PREVOST

**SAFETY
RECALL**

SR13-03E

DATE : MARCH 2013	SECTION : 23-ACCESSORIES
SUBJECT : AUTOMATIC FIRE DETECTION AND SUPPRESSION SYSTEM – LINEAR THERMAL DETECTOR REPLACEMENT

PART 3: REMOVAL OF IR SENSOR AND INSTALLATION OF IR SENSOR SUPPORT BRACKET ON EPA2007 VEHICLES ONLY (FOR EPA2010 VEHICLES, JUMP TO PART 4)

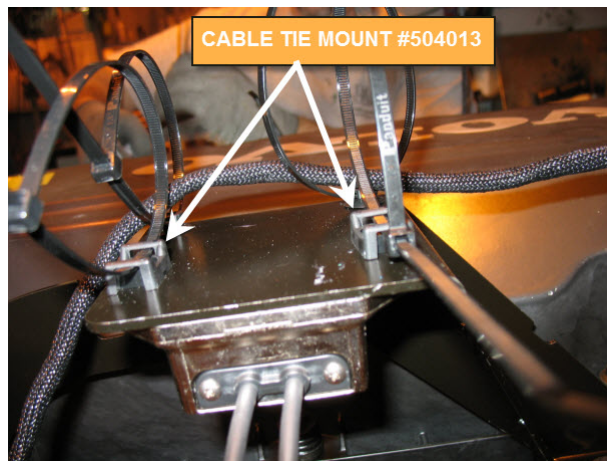
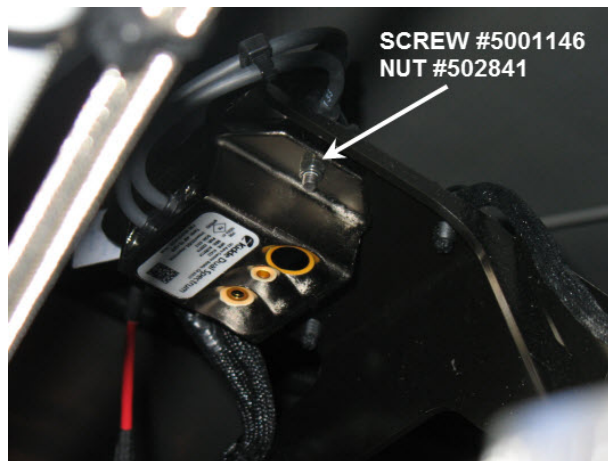
1. Unplug connector **A131A** and **A131B** if applicable from the IR optical detector.
2. Dismount the IR sensor.
3. Install the IR sensor on support bracket #068552 using cap screw #5001146 (2x) and nut #502841 (2x). Install two (2) cable tie mounts #504013 as shown on the second image below.

4. Mount support bracket complete with IR sensor along the valve cover (see image below) using bolt #502830 (2x) and washer #5001833 (2x).

PART 4: REMOVAL AND REPLACEMENT OF IR SENSOR SUPPORT BRACKET ON EPA2010 VEHICLES (FOR EPA2007 VEHICLES, JUMP TO PART 5)

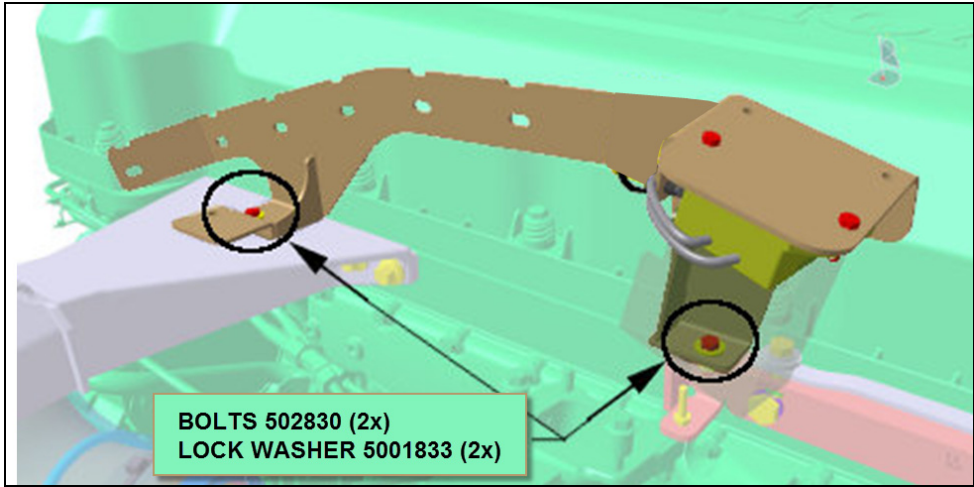
1. Disconnect the existing LTD connector and the power supply connector from the IR optical detector. The IR optical detector is located on turbocharger side, close to the valve cover.
2. Remove the existing IR sensor support bracket. Dismount the IR sensor from support bracket and install similarly on the new support bracket #068552 using existing hardware (see following pictures).
3. Using existing hardware, install new support bracket #068552 complete with IR sensor similarly as the former one.

REMOVE EXISTING SUPPORT BRACKET (shown) AND REPLACE WITH #068552

PART 5: REPLACEMENT OF LTD (EPA2007 & EPA2010)

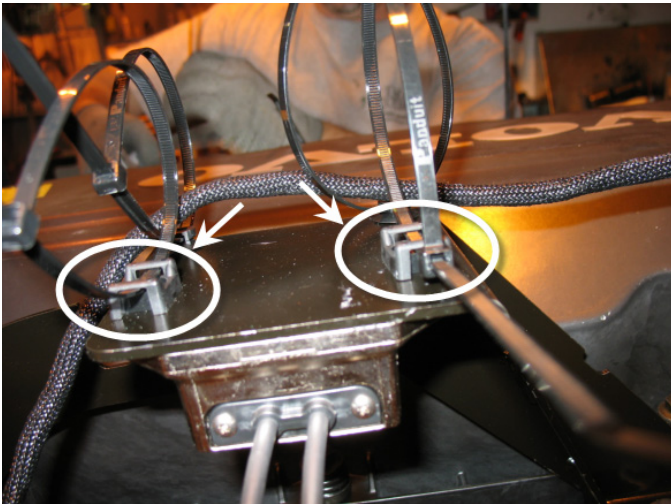
1. Remove the existing LTD routed around the engine simultaneously with the installation of new LTD #068564, while proceeding successively from one attachment point to the other. **Take note that the LTD will not be routed under the starter anymore.**

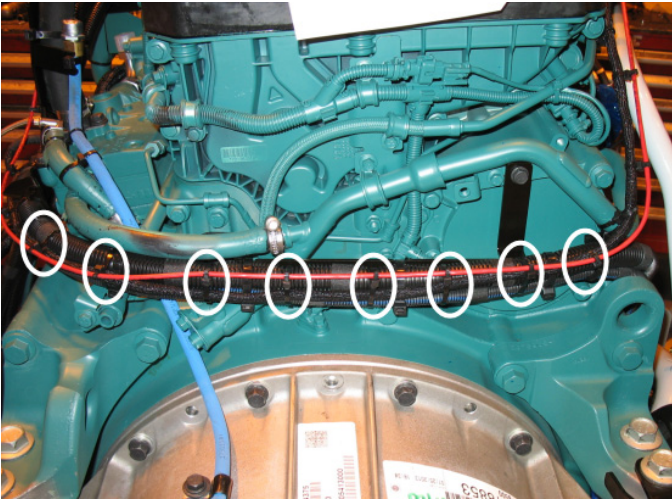
STEP 3-G
Secure LTD on nearby harnesses using double loop cable ties. Refer to the image for proper attachment points. **Do not route the LTD under the starter as previously routed.**
